R20TS0747EC0100  
Rev.1.00  
Sep. 16, 2021

CS+ Code Generator for RH850,  
AP4 Coding Assistance Tool for RH850

- Notes on using CSIH Master receive and Master transmit/receive operation mode

Figure 1-1 Setting of CSIH operation mode

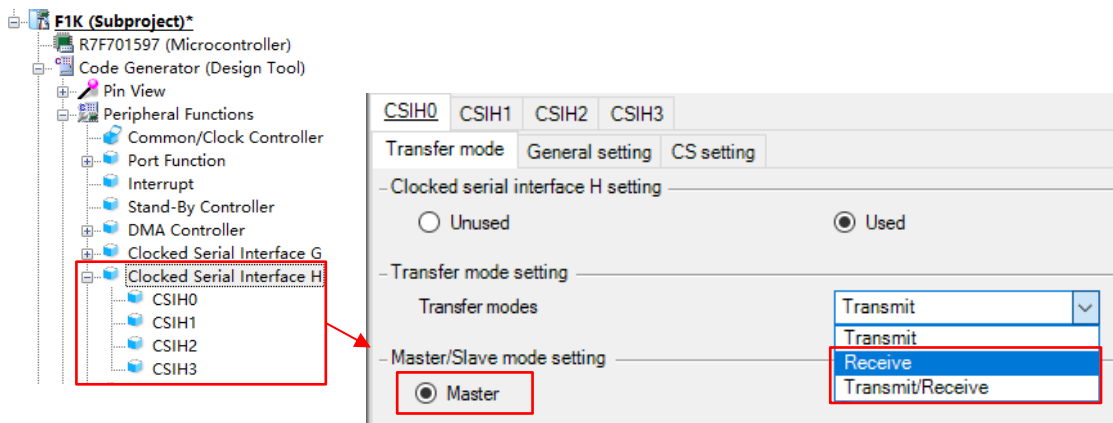
When using CSIH as Master “Receive” and Master “Transmit/Receive” mode (refer to figure 1-1), master can only receive the first data correctly. From the second data, master fails to receive.

- RH850/F1K:  
CSIH0, CSIH1, CSIH2, CSIH3

User can manually modify the register setting code in the following source file

- Source file: “r\_cg\_csih\_user.c”.
- Function: “void r\_<csihn>\_interrupt\_receive (void)”

```
void r_Config_CSIH0_interrupt_receive(void)
{
    uint8_t err_type;
    uint16_t temp;
    .....
    else
    {
        temp = g_csih0_rx_total_num;
        if (temp > g_csih0_rx_num)
        {
            *gp_csih0_rx_address = CSIH0.RX0W;
            gp_csih0_rx_address++;
            g_csih0_rx_num++;
            CSIH0.TX0W |= 0U;          --> change "=" to "|="
        }
        .....
    }
}
```
